**Briargate Bridge at Sand Creek  
Design Report  
Sand Creek Drainageway  
El Paso County, Colorado**

Kiowa Project No. 19032

December 6, 2021

CDR-21-013

HEC-RAS Plan: Proposed Floodway River: Sand Creek Reach: Briargate Only Profile: 100yr

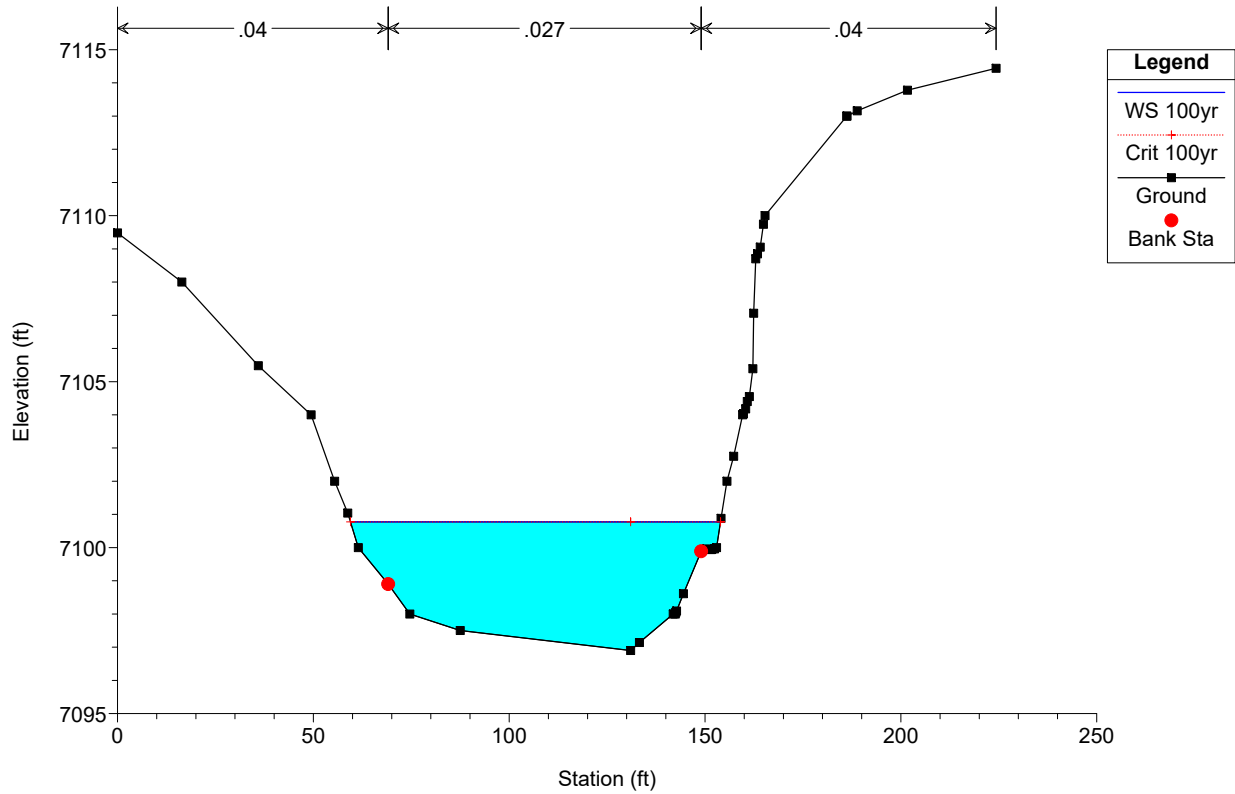
Please run with the DP-69 flows also (1870 cfs) and provide that table also
